主旨: [FI] S.16 Application No. A/YL-KTN/1049 - FI to address departmental comments

1st Further Information

(S.16 Planning Application No. A/YL-KTN/1049)

Responses-to-Comments

Title:
 Drainage Proposal-Layout

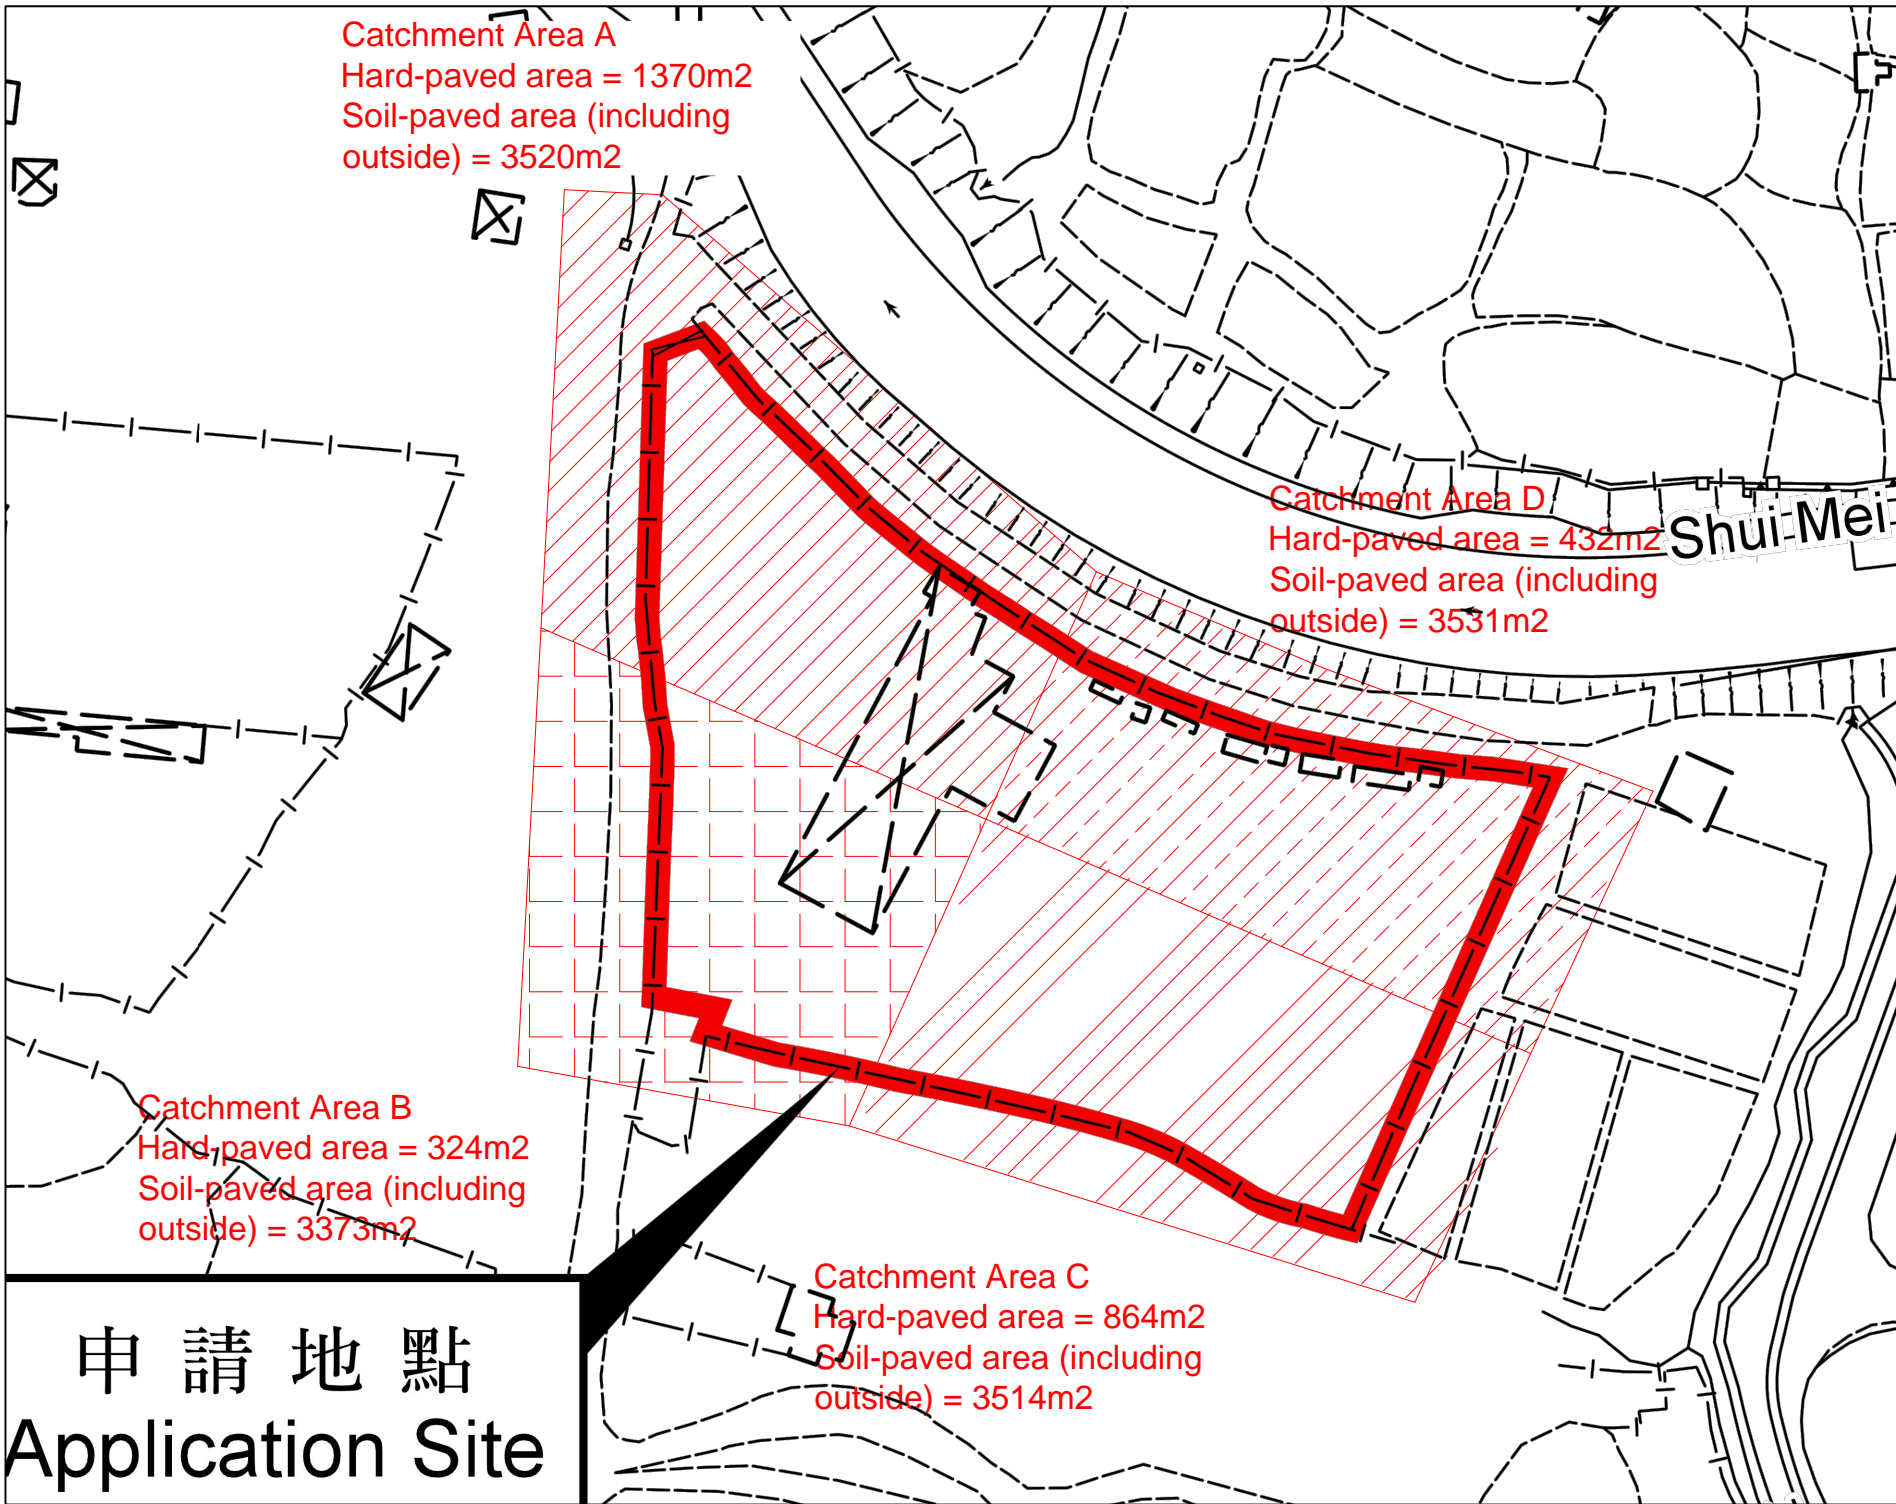
(e)	According to our record, there is existing drains connecting to manhole SCH1028770. Please indicate on drainage plan and update the manhole details.	It is indicated and updated.

(f)	The proposal should indicate how the runoff (the flow direction) within the site would be discharged to the proposed u-channel.	The fall direction is indicated.

(g)	The existing drainage facilities, to which the stormwater of the development from the subject site would discharge, should be	It is indicated and connection details are provided.

- Note:**
1. Catchpit (CP7) with desilting facility shall follow CEDD standard drawing No. C24061.
 2. Catchpit and UC follows Typical Details of Geotechnical Manual for Slope Fig.8.10 and Fig.8.11 respectively.
 3. All UCs are covered by cast iron
 4. The inverted level of the connection point shall be verified on site prior the commencement of work

Title:
 Section

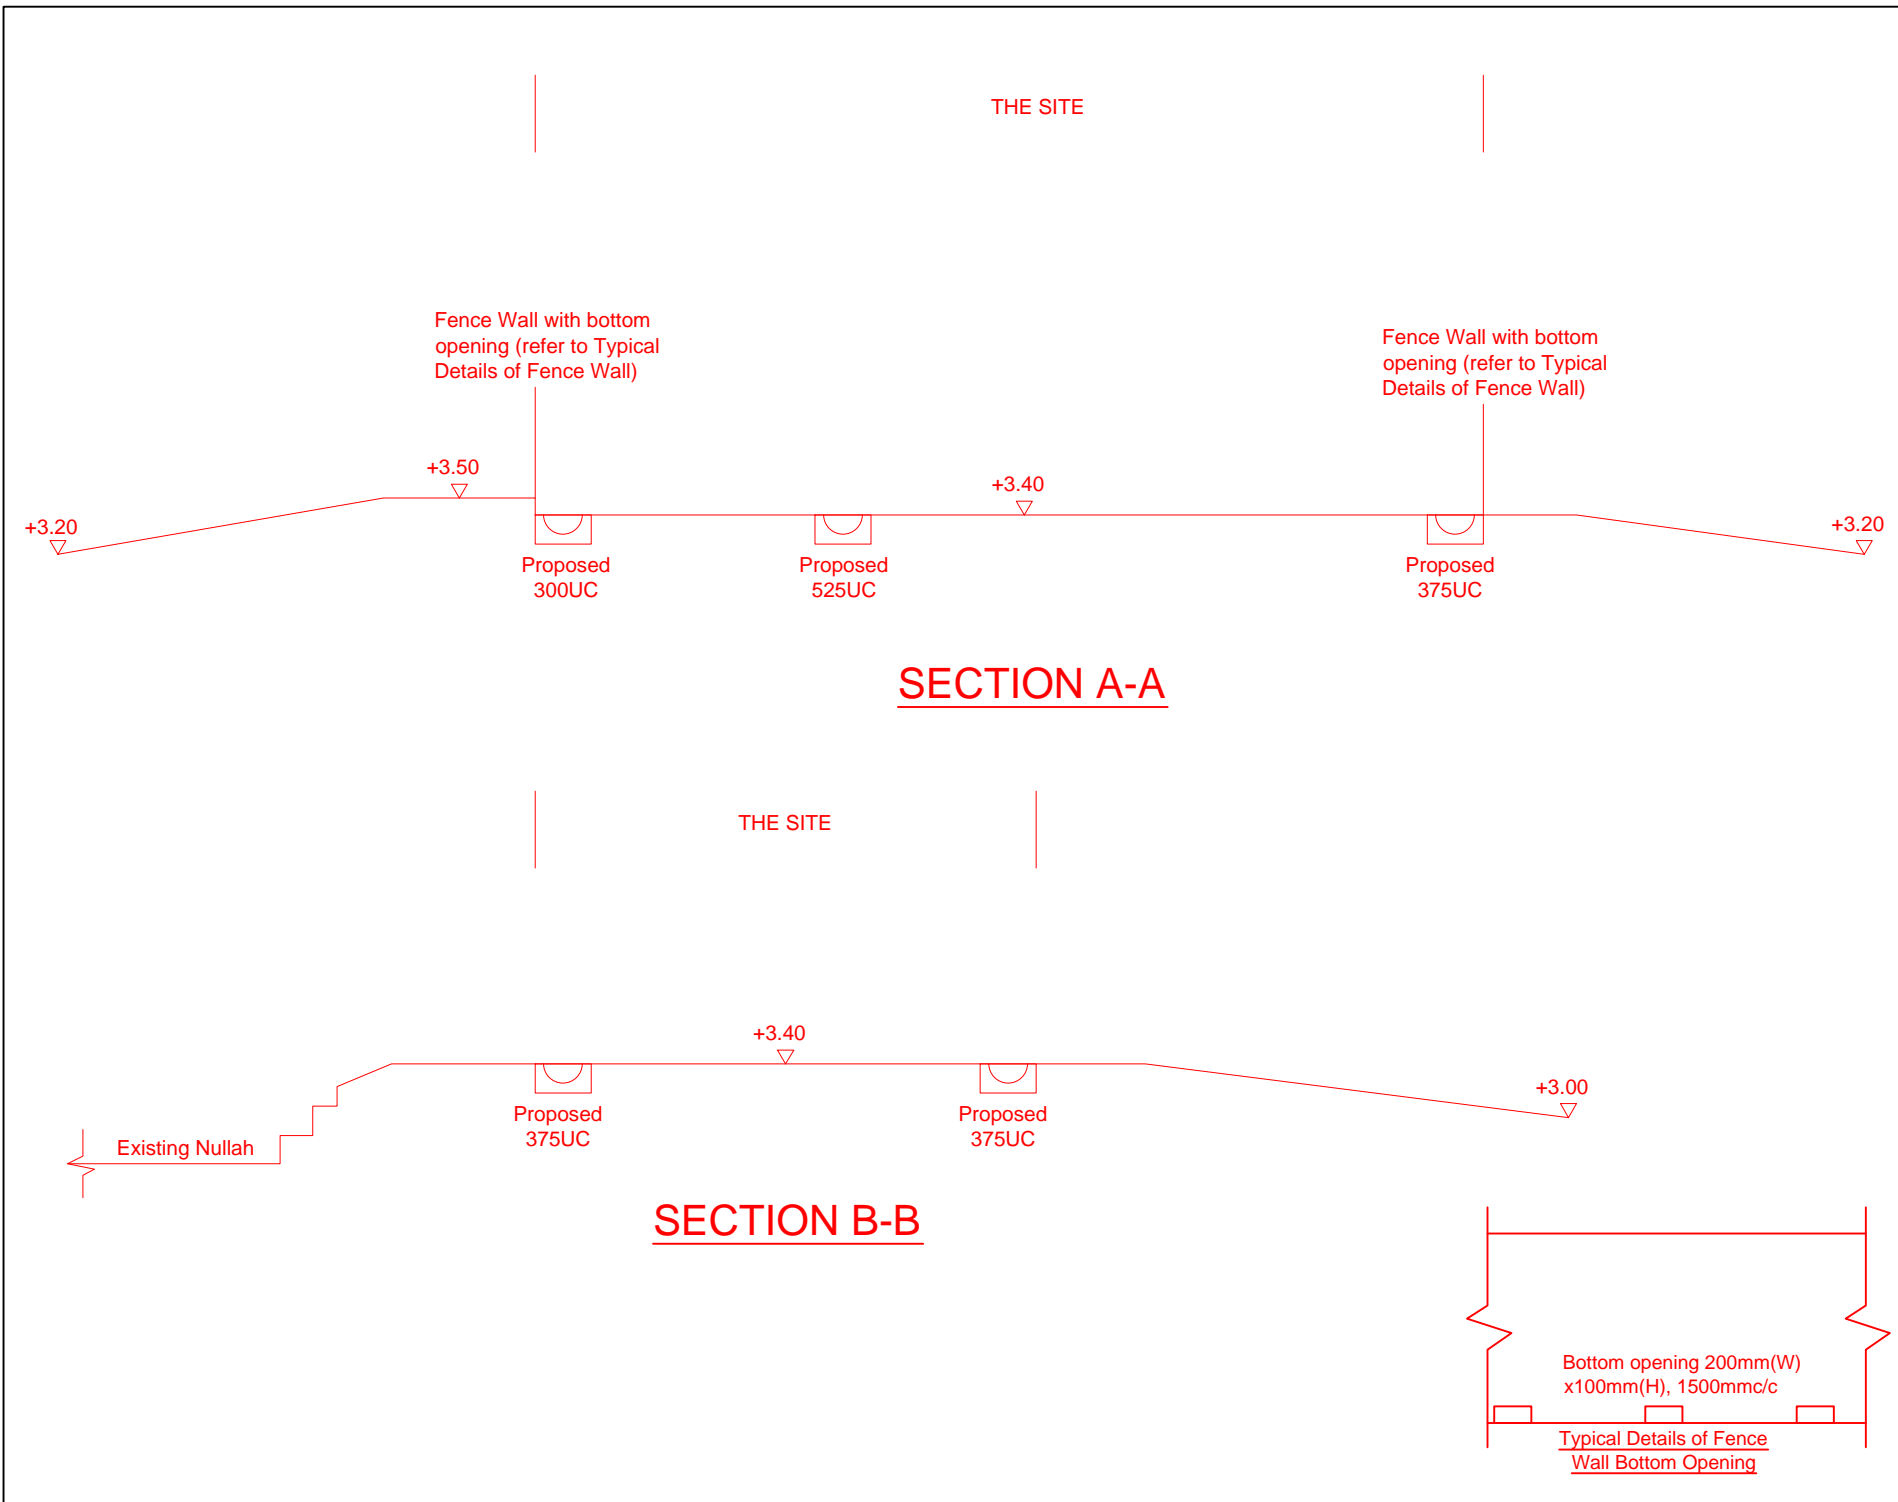
(i)	Cross sections showing the existing and proposed ground levels of the captioned site with respect to the adjacent areas should be given.	Cross sections are provided.

Figure 1 - Chart for the rapid design of U-shaped and half-round channels up to 600 mm

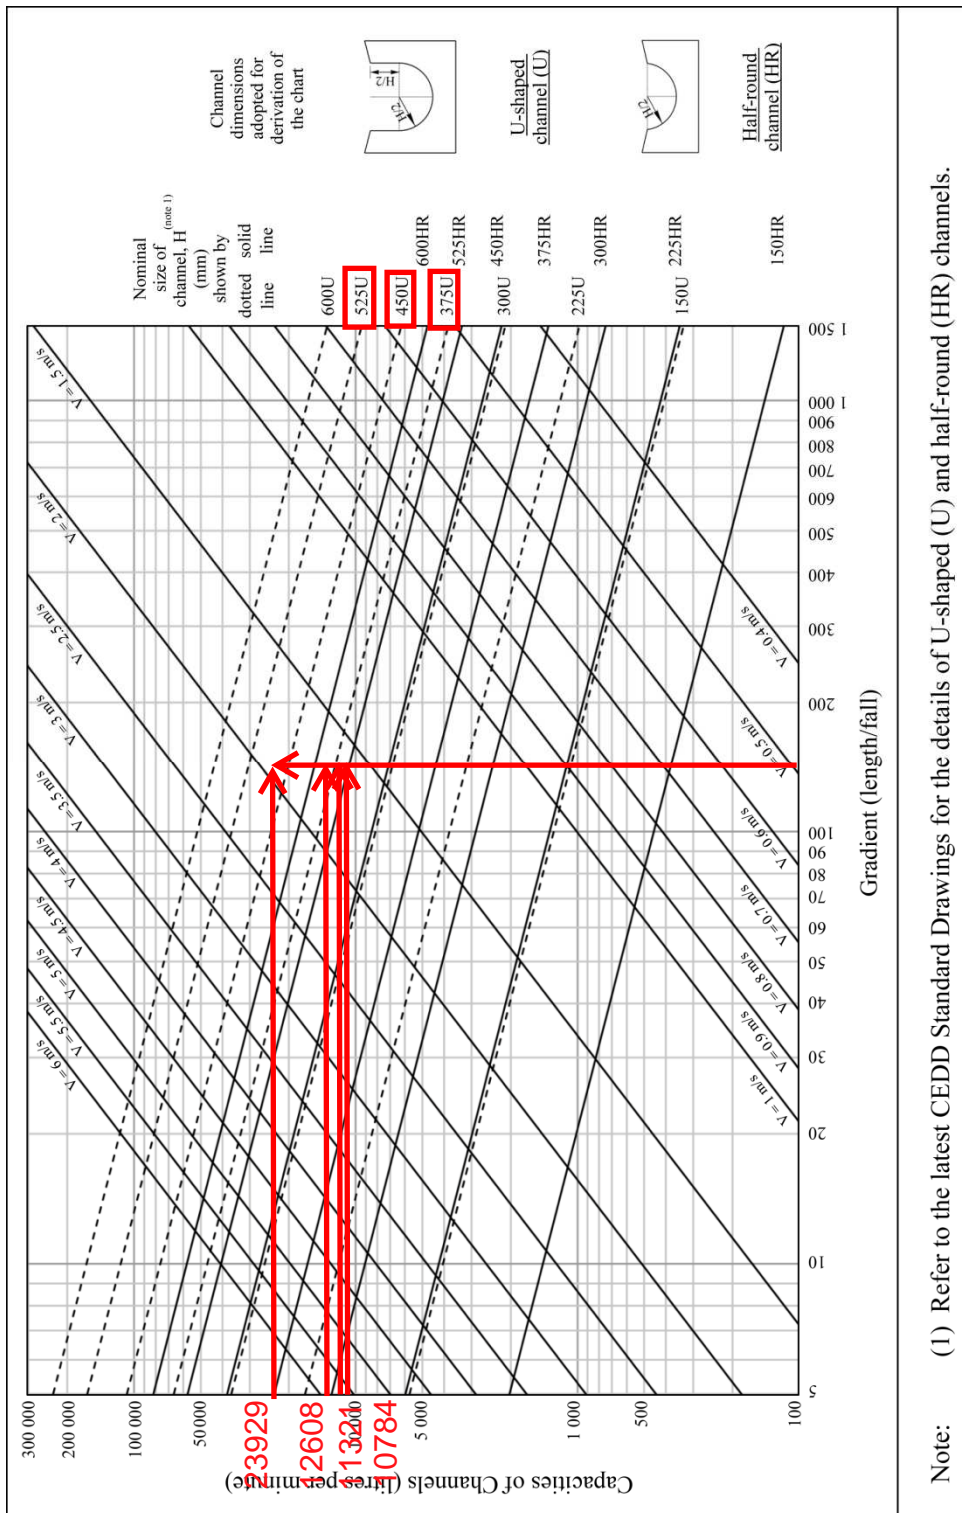
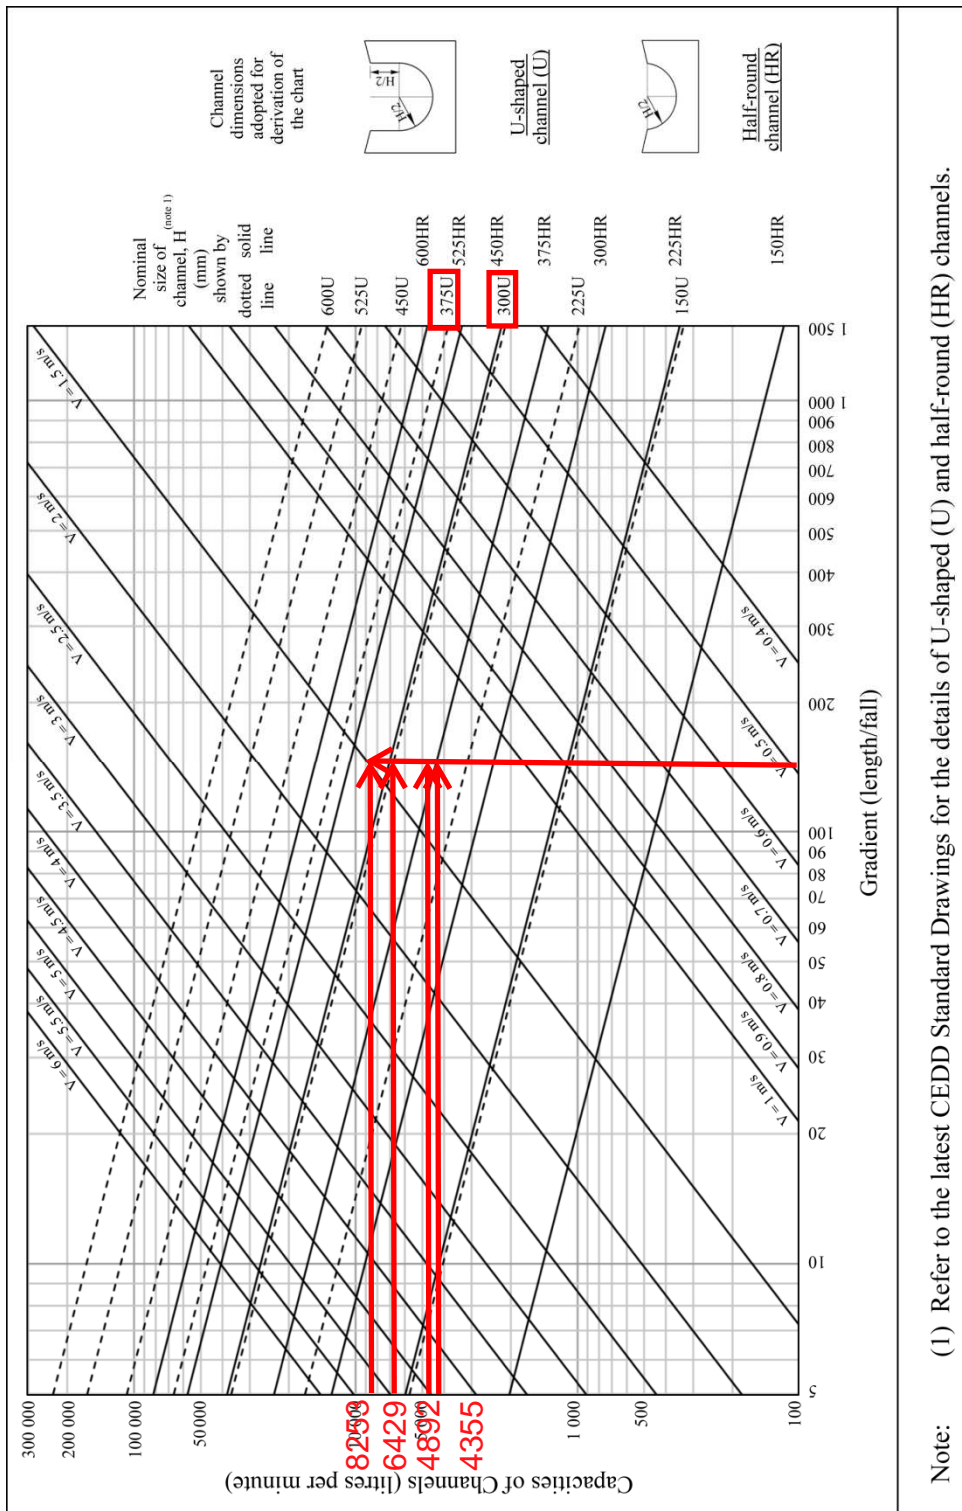
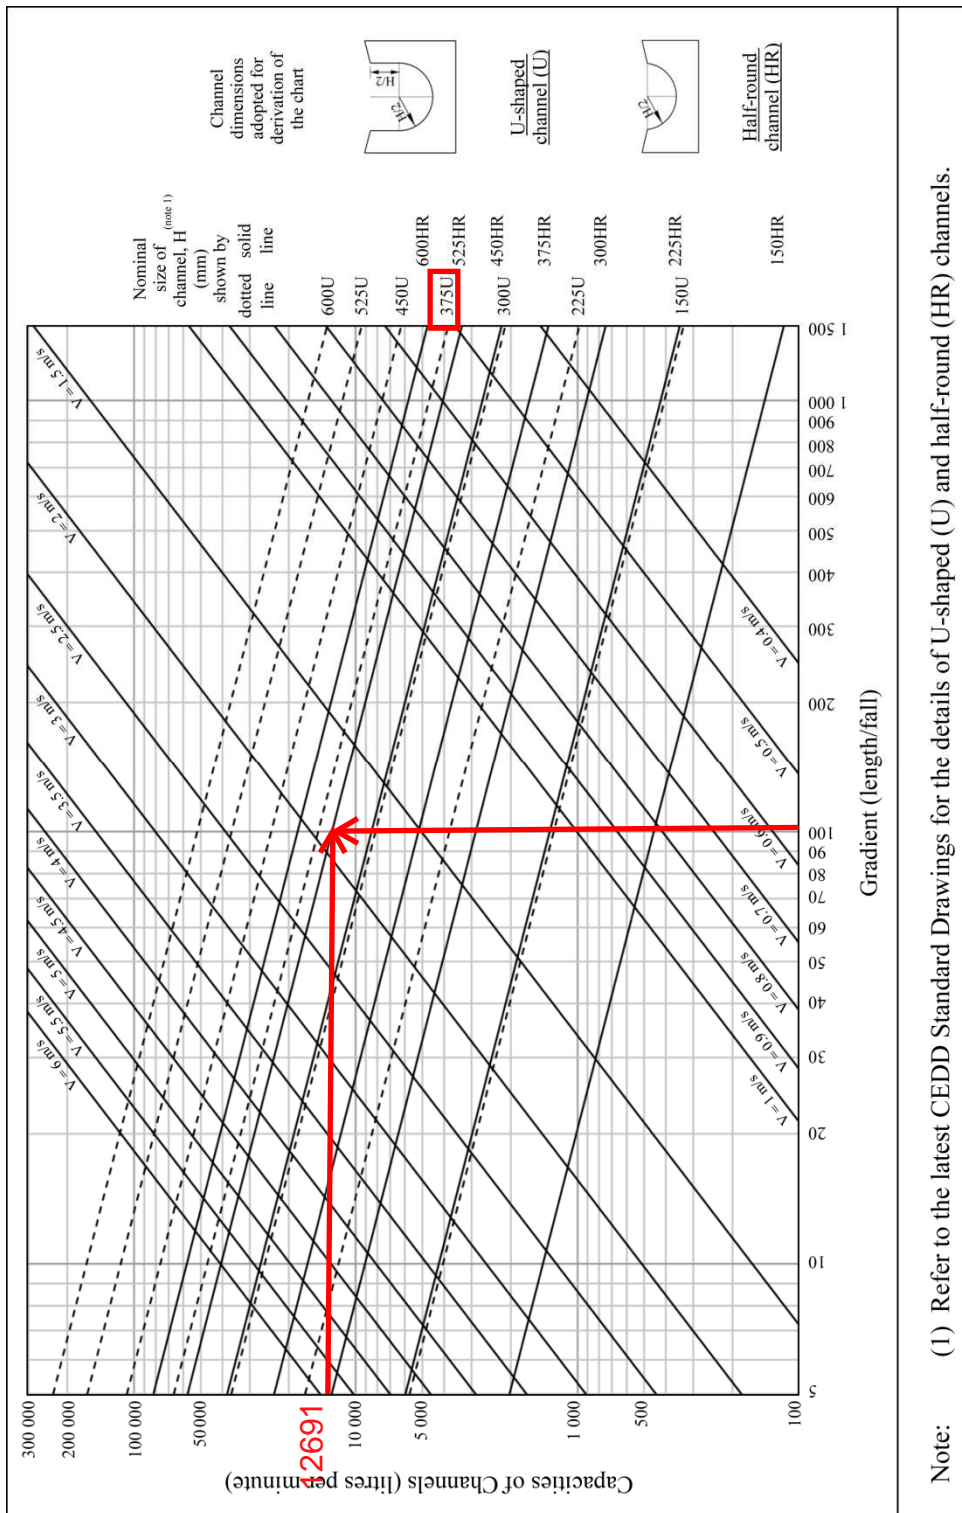
(b)	GEO Technical Guidance Note No. 43 should be adopted for u-channel checking as Figure 8.7 of the Geotechnical Manual for Slopes (GCO, 1984) was superseded.	GEO Technical Guideline Note No.43 is adopted.

GEO Technical Guidance Note No. 43 (TGN 43)
Guidelines on Hydraulic Design of U-shaped and Half-round Channels on Slopes
